## ADDENDUM NO. 04

Project Name: Aston Township Municipal Complex

Project No.: 2301.00-22

Date of Issue: April 23, 2024

M-001

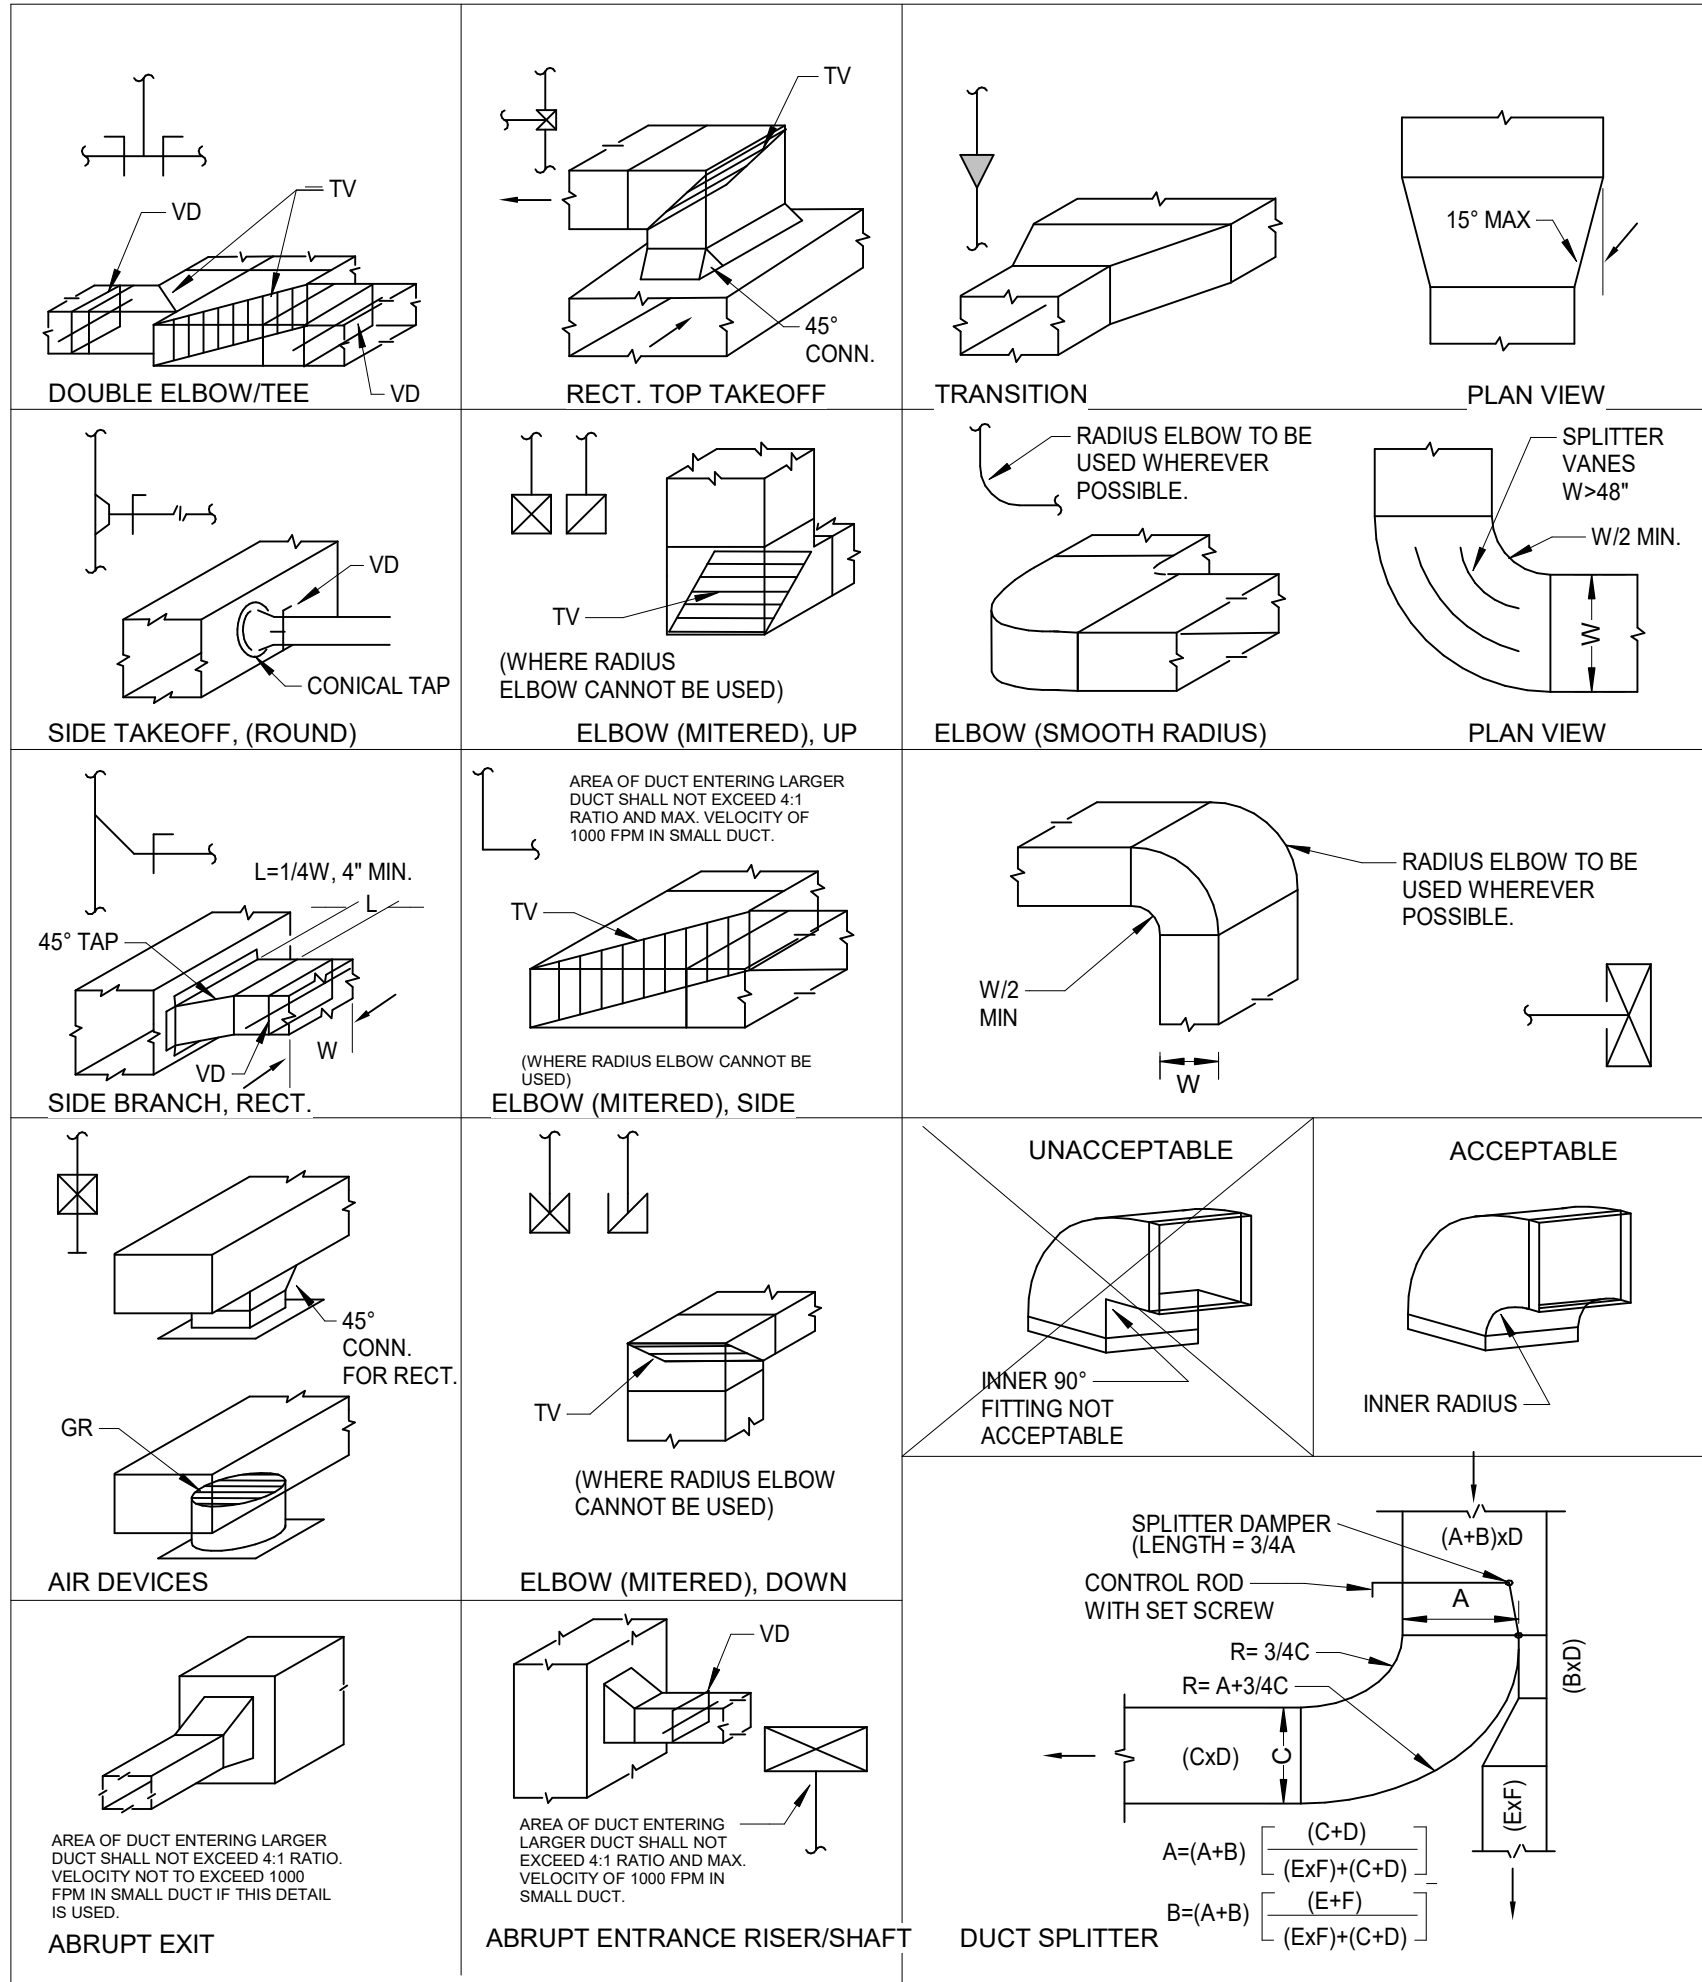
24. Reference to Sheet M-001 – Cover Sheet – Mechanical: Sheet M-001 – Cover Sheet – Mechanical is being reissued as part of this addendum. The following clarifications have been made:

- a. The Drawing List has been updated to reflect revised sheets contained in this addendum.
  - b. Mechanical General Notes 19, 23, 24, 25, and 26 have been deleted.

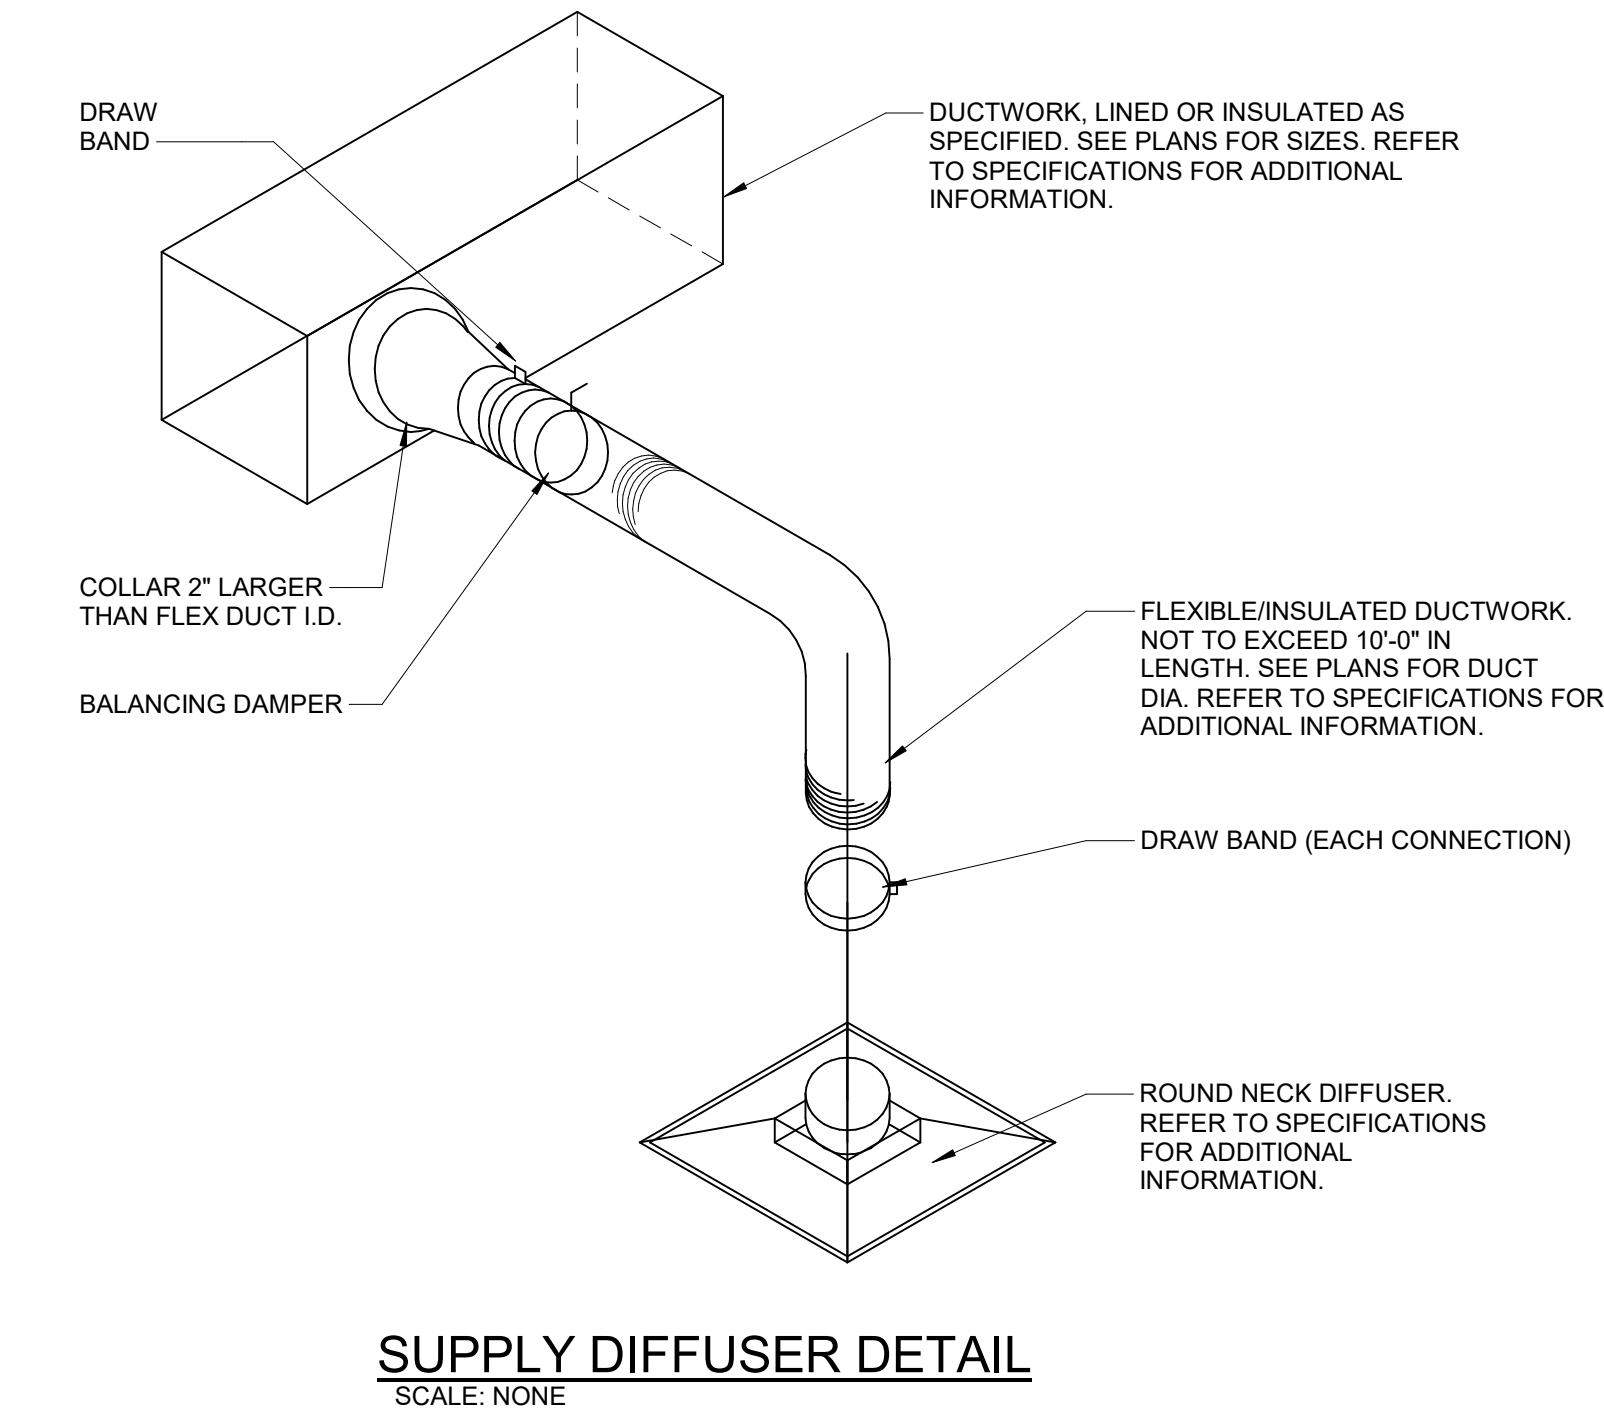
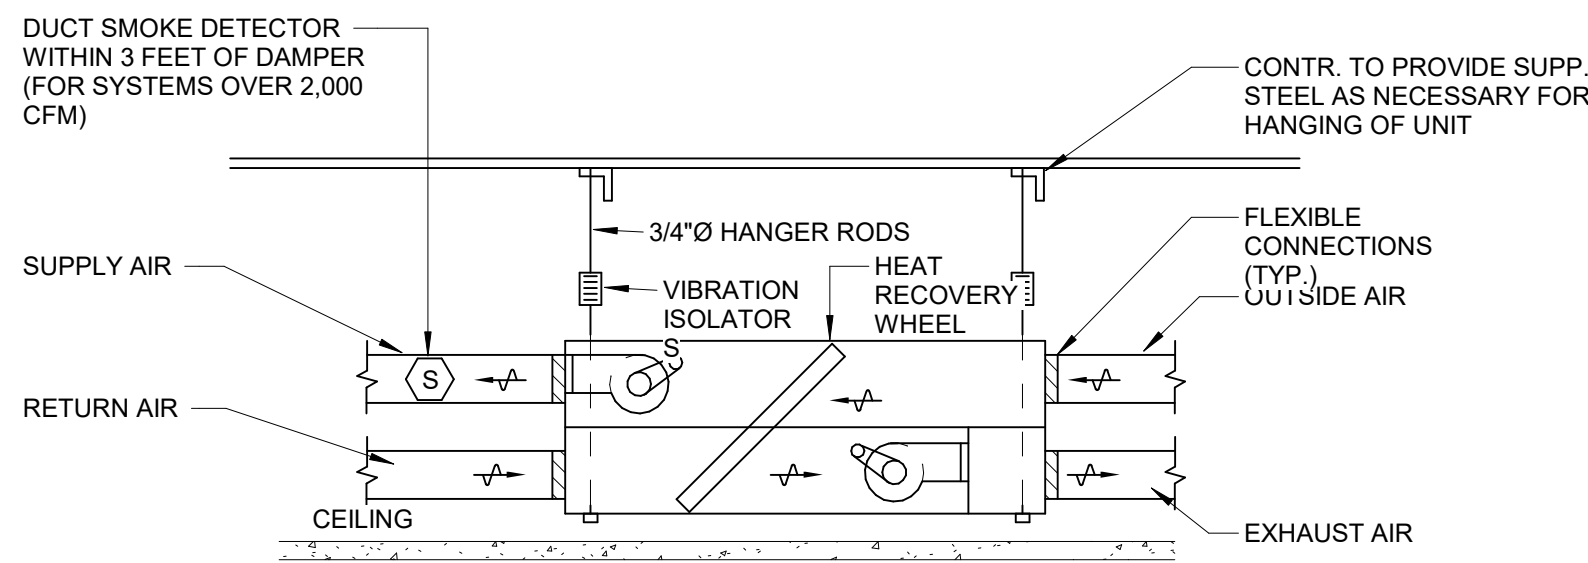
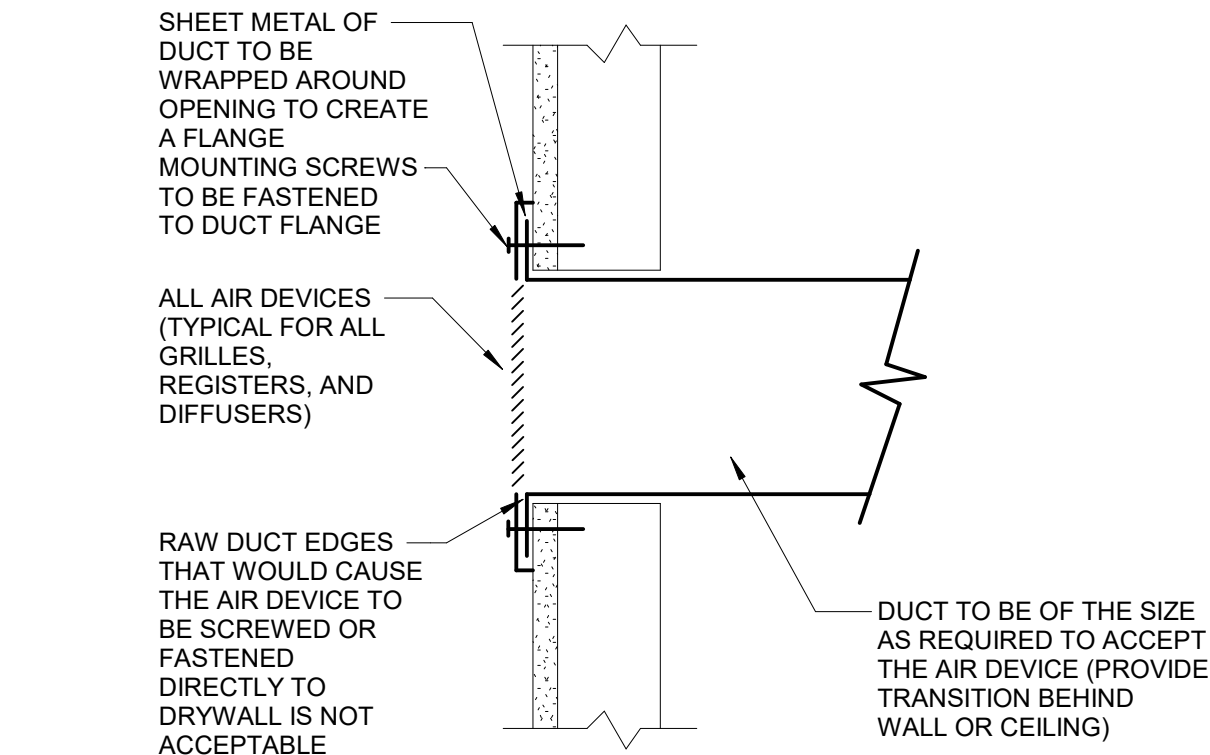
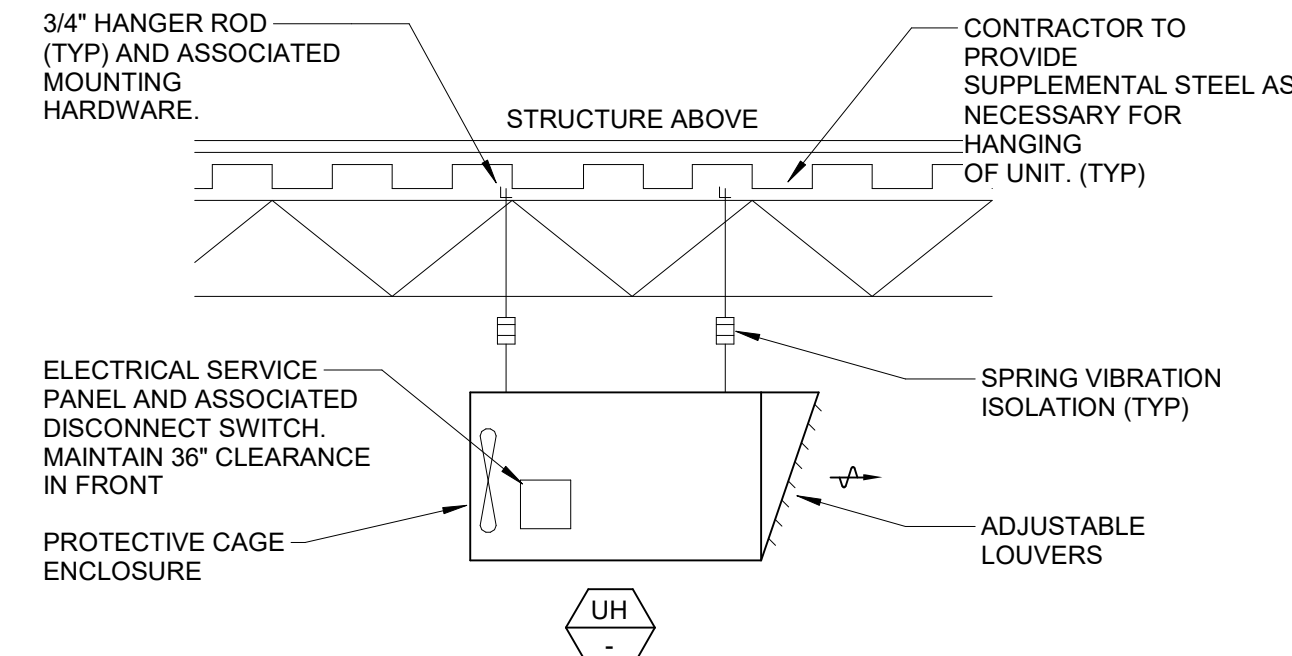
26. Reference to Sheet M-202 – Details - Mechanical: Sheet M-202 – Details – Mechanical is being reissued as part of this addendum. The list of Mechanical Symbols and Abbreviations has been added.
